Project Code & Schematics Subject: MS21 MP Main Board

Title Index Page		
Size A3	Document Number (MS21-1-01)MainBoard (MBX-164) TYPE2	Rev 1.1
Date: Thursday, August 10, 2006	Sheet 1	of 78

MS20 MP to MS21 DVT Change History

FOXCONN HON HAI Precision Ind. Co., Ltd. CCPBG - R&D Division		
Title HDMI SiI1930		
Size A3	Document Number (MS21-1-01) MainBoard (MBX-164) TYPE2	Rev 1.1
Date: Thursday, August 10, 2006	Sheet 34	of 78

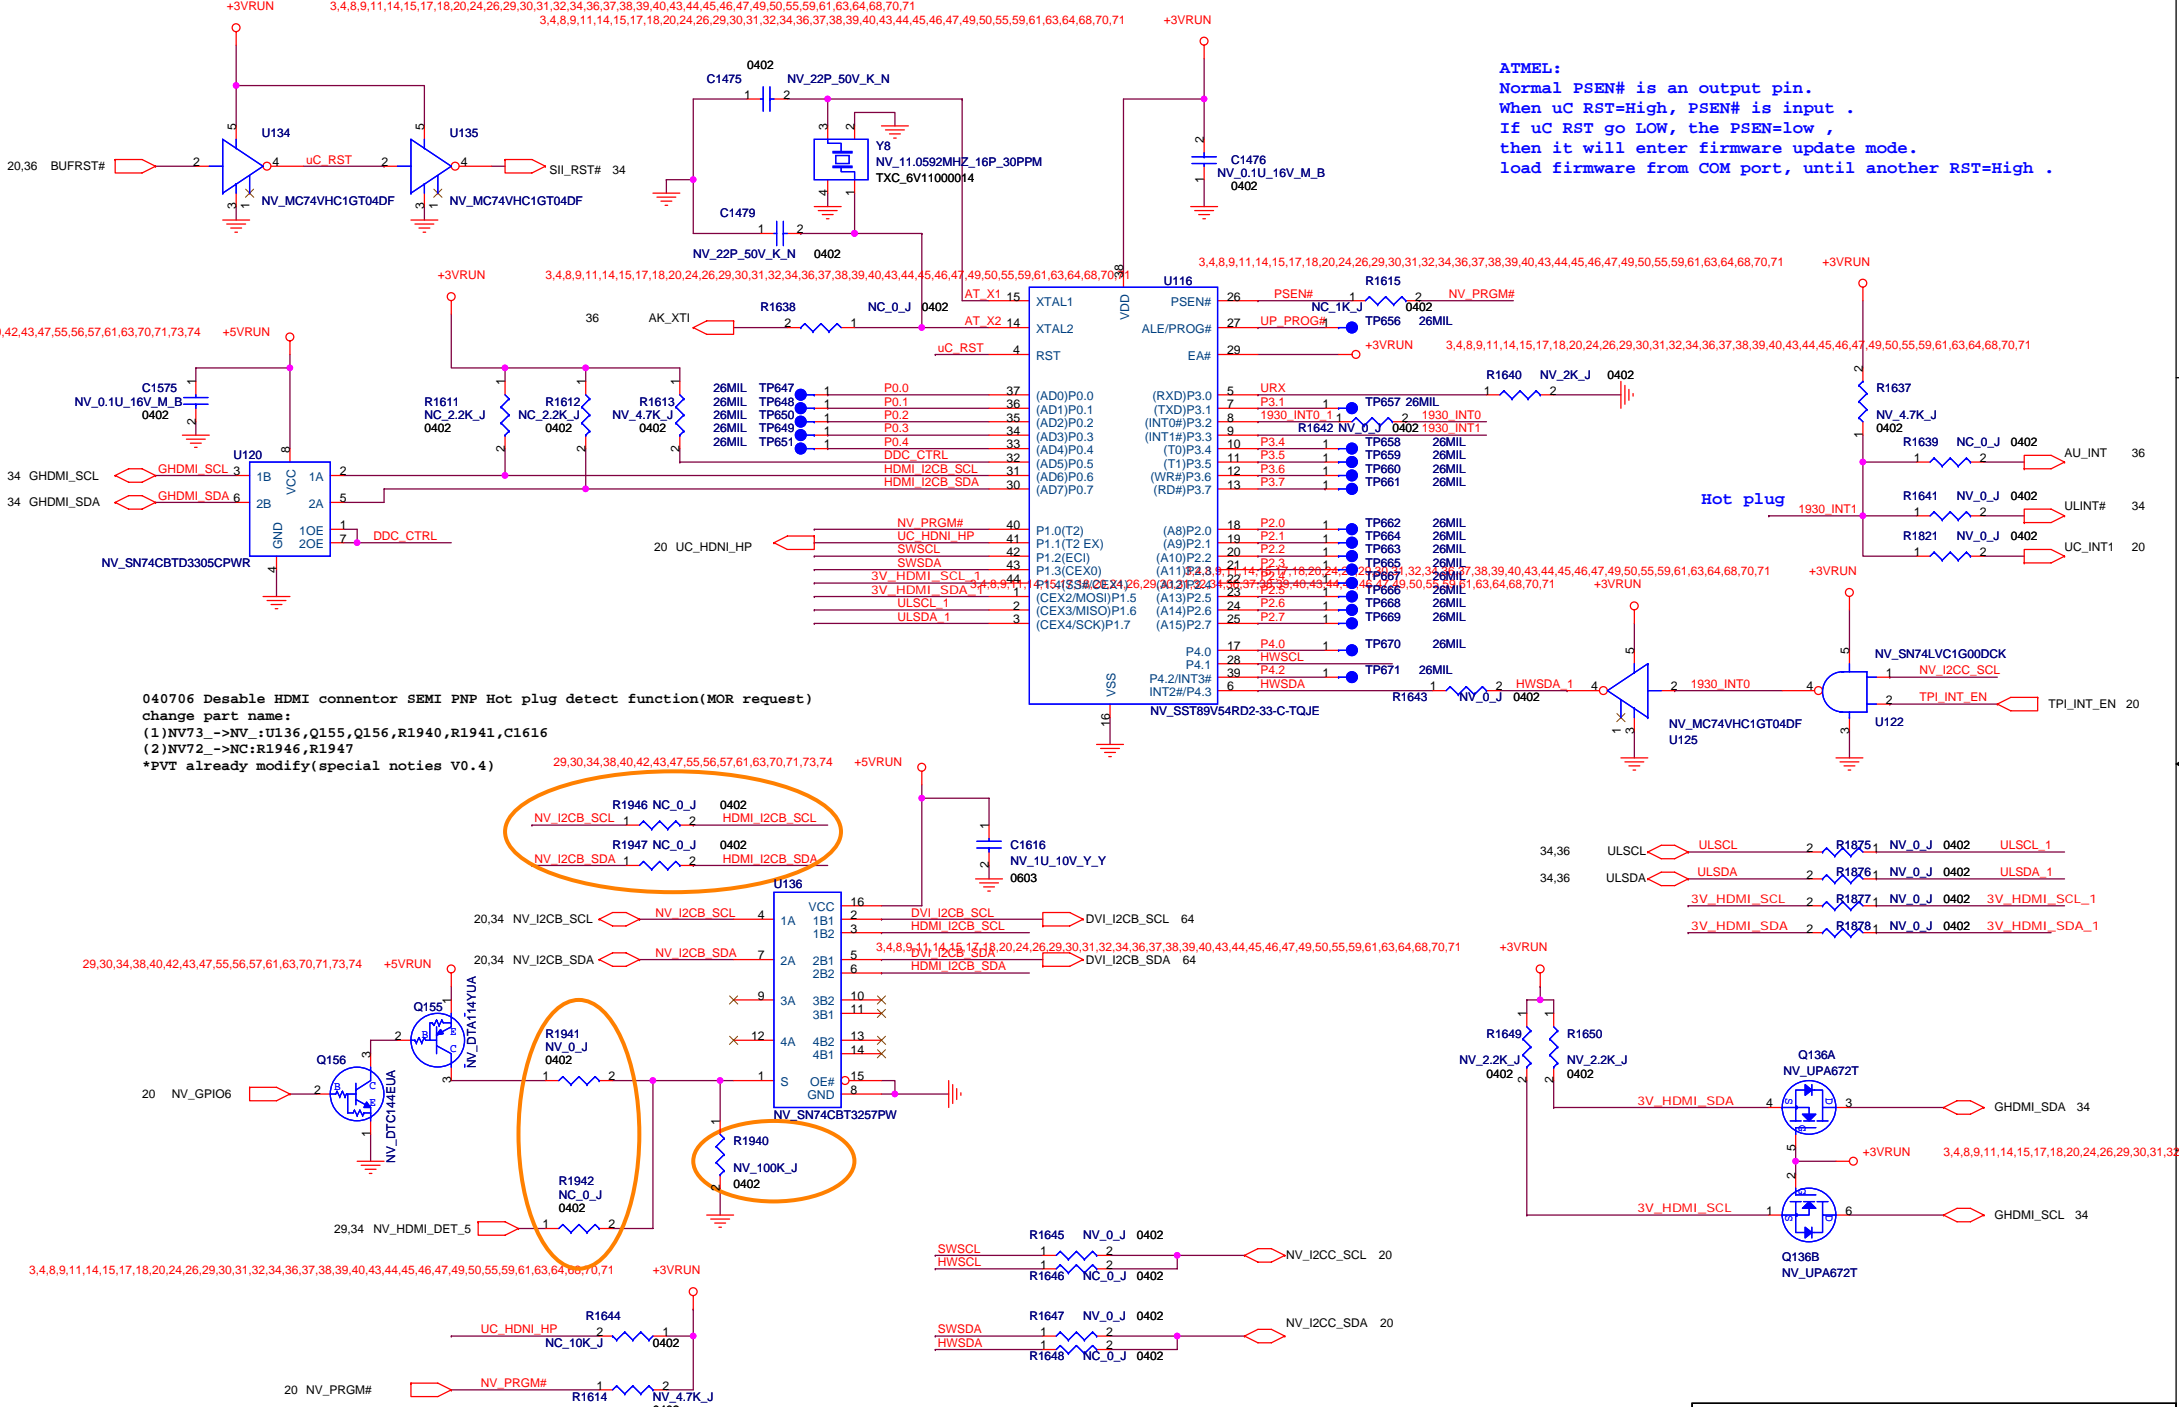
5/14
 US Silicon Image ATC test HDMI DDC
 capacitance fail(>50pF)change U128 no stuff
 Basis on MS20 MP ECR
 U128 VCC add back up res.(R1962)no stuff
